## AMENDMENT 2

- 2 BUNGALOW HOMES ADDED
- N. QUEMOY CT. EXTENDED NORTH
- BUFFER LANDSCAPE ALONG PICADILLY PHASED

GREEN VALLEY RANCH EAST  
PRELIMINARY SITE PLAN #5  
TITLE: KEYMAP  
DATE: March 8, 2023

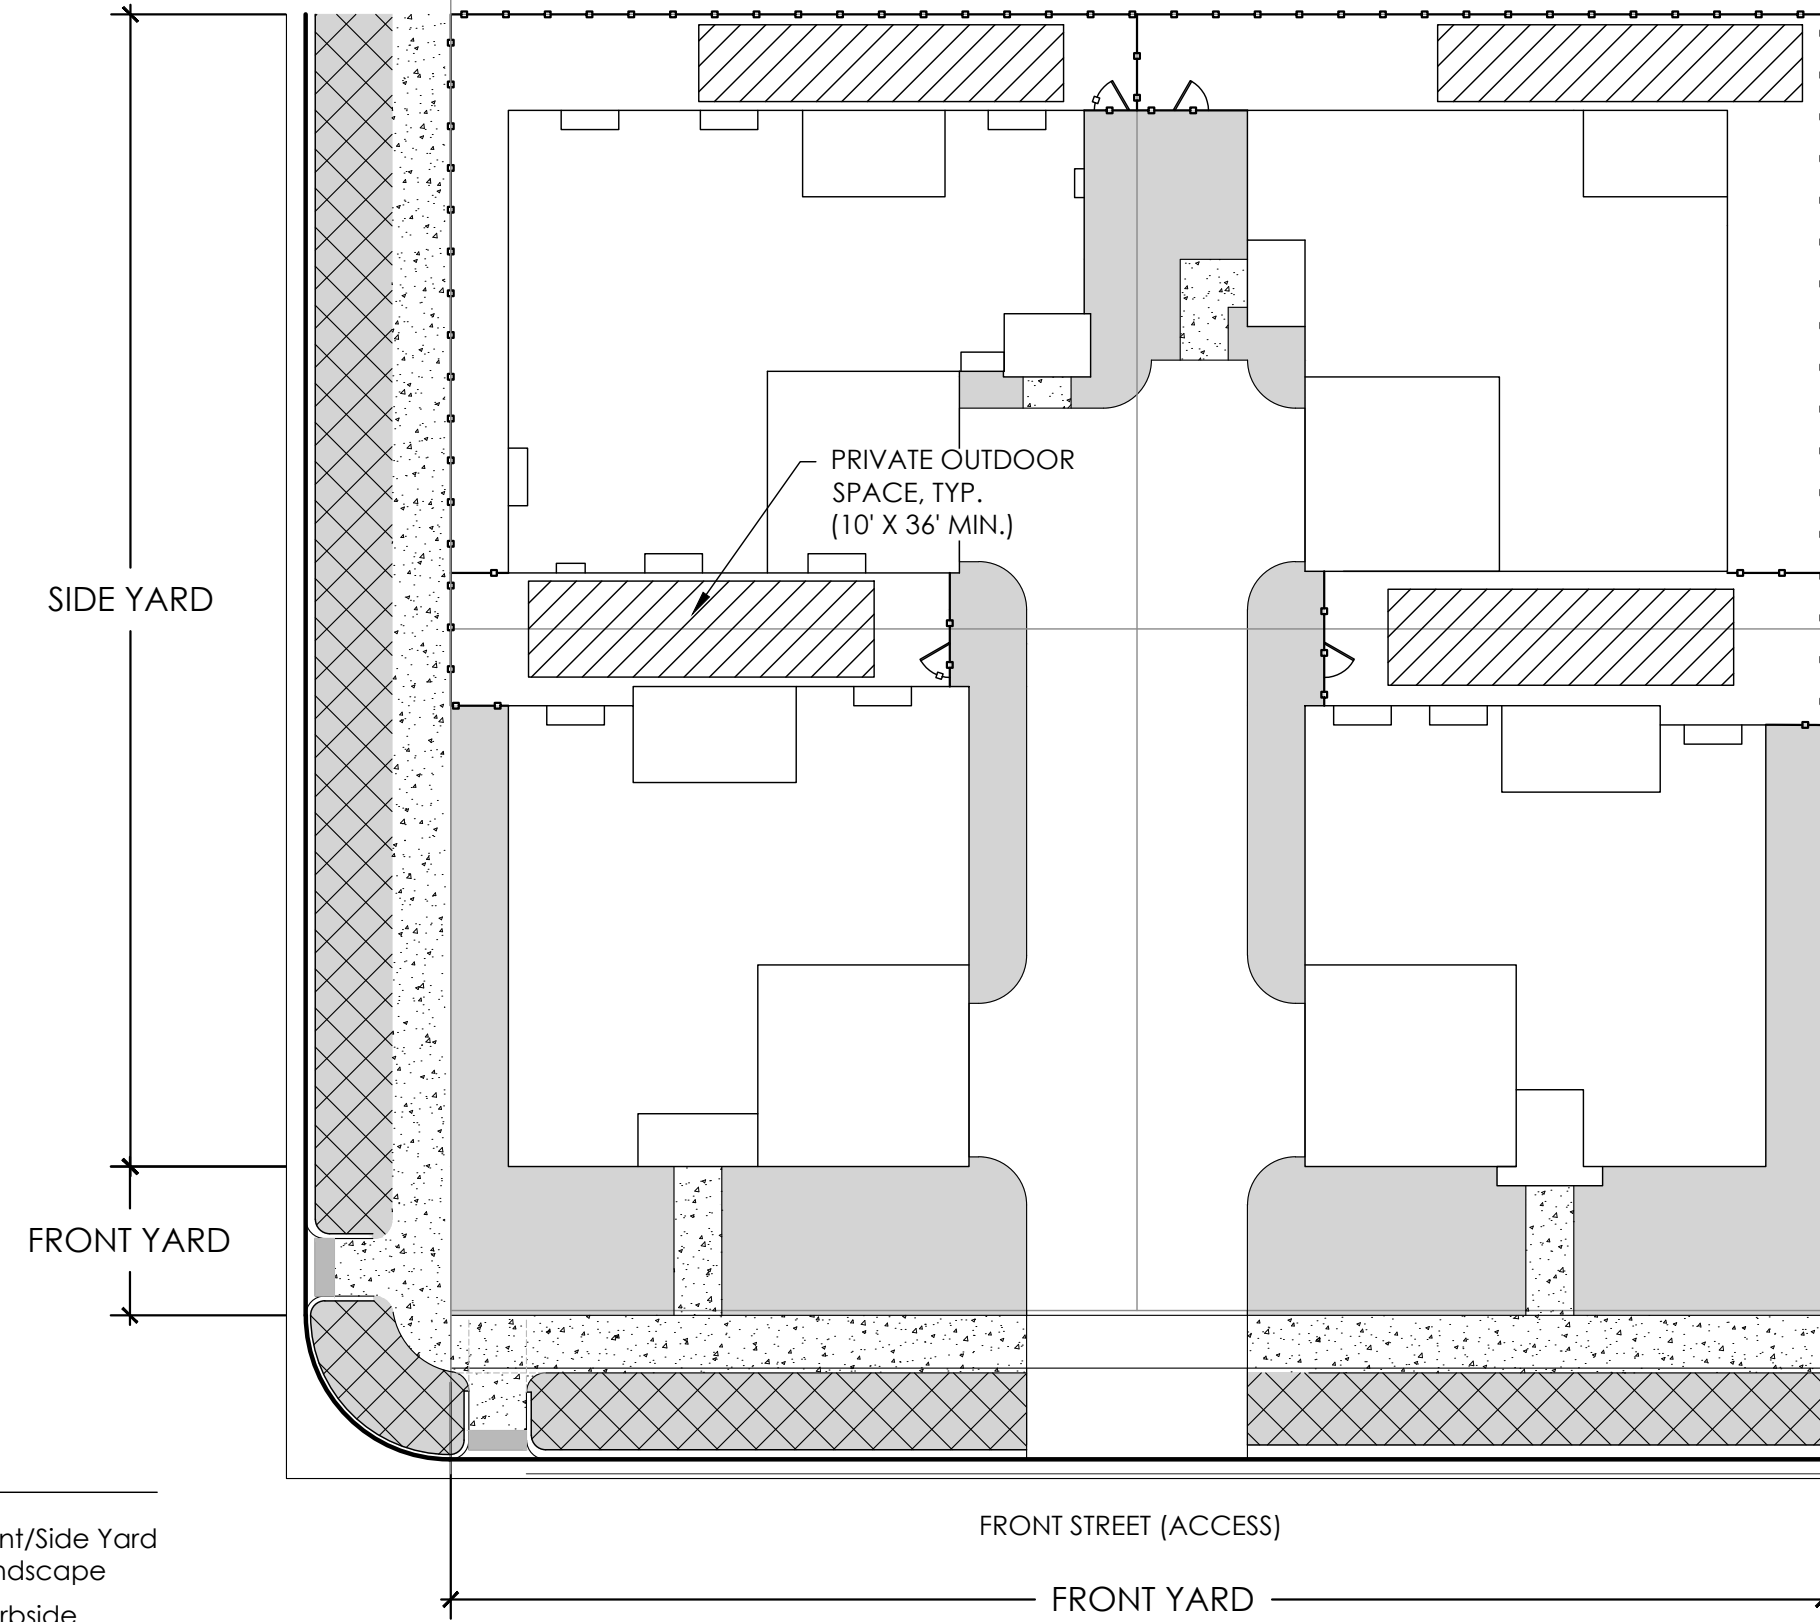
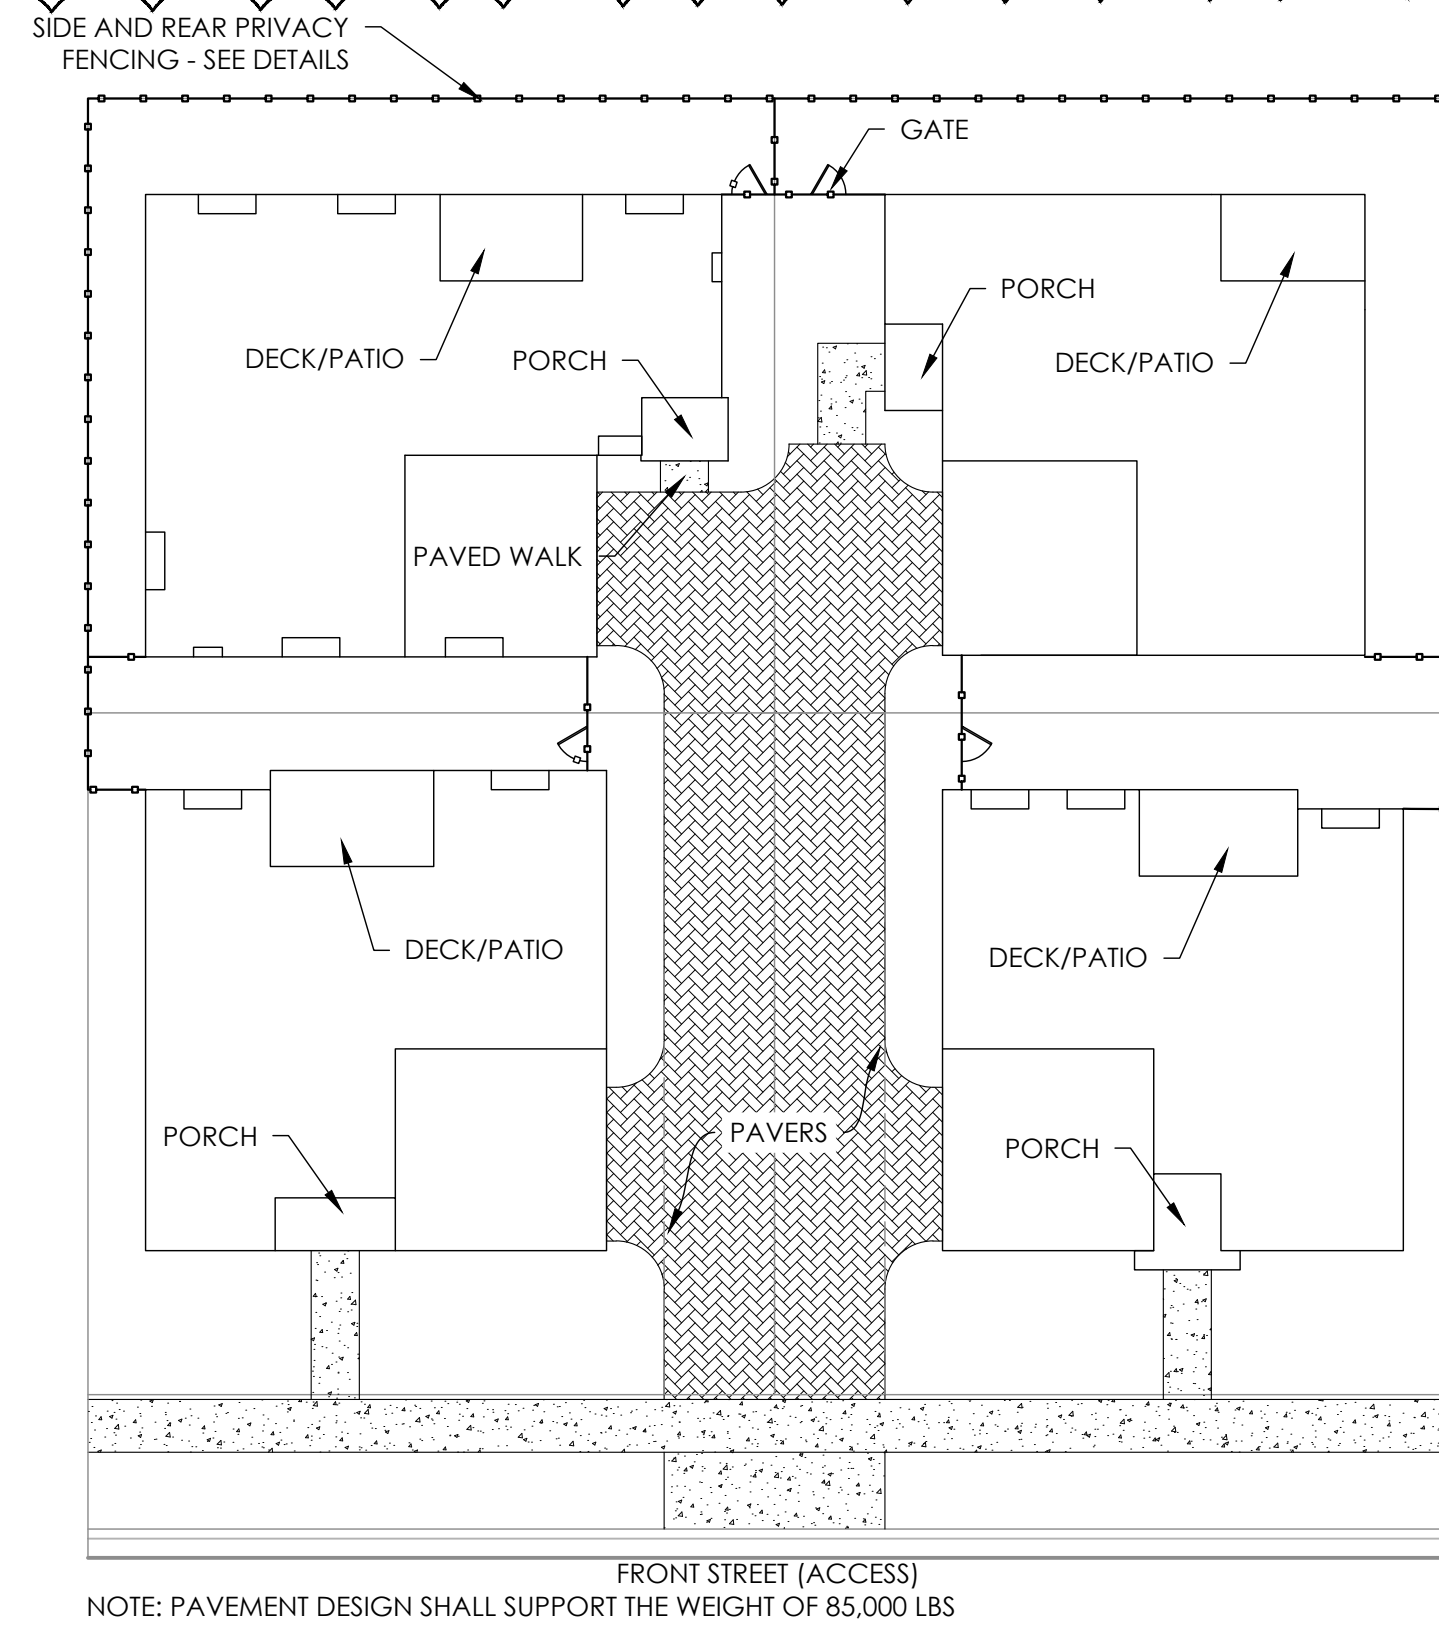
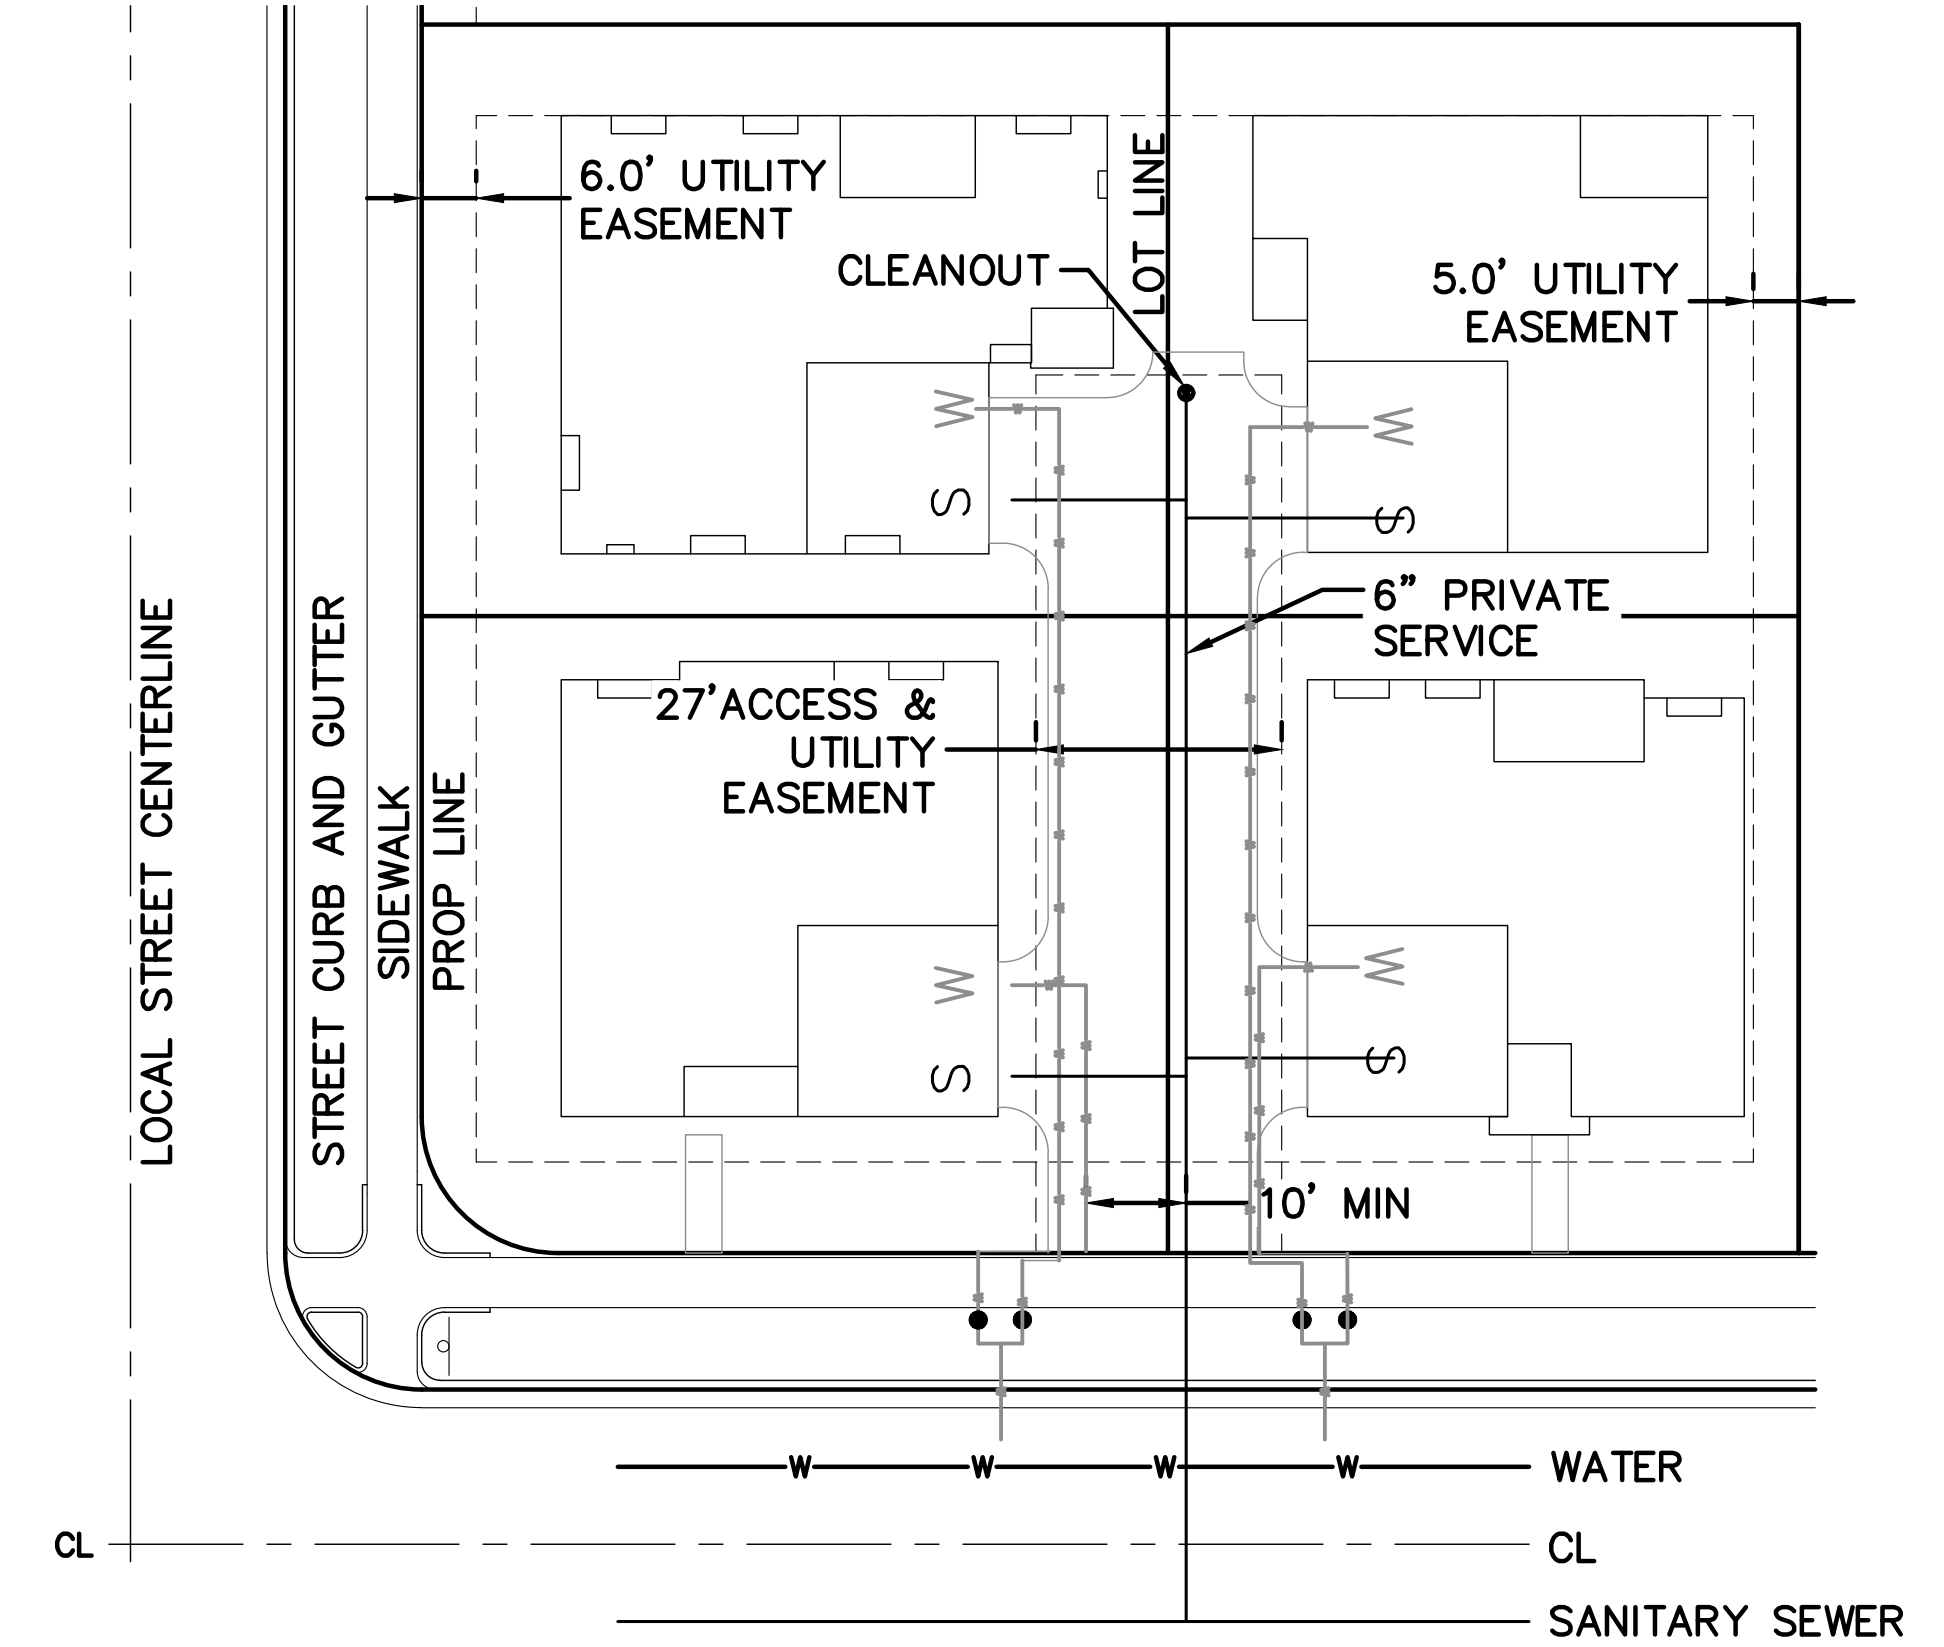
1  
AMENDMENT 1  
- BUNGALOW 6 PACK TYPICALS ADDED

3  
AMENDMENT 3  
- ADDED FRONT LOADED DUPLEX SETBACK AND EASEMENT TYPICAL
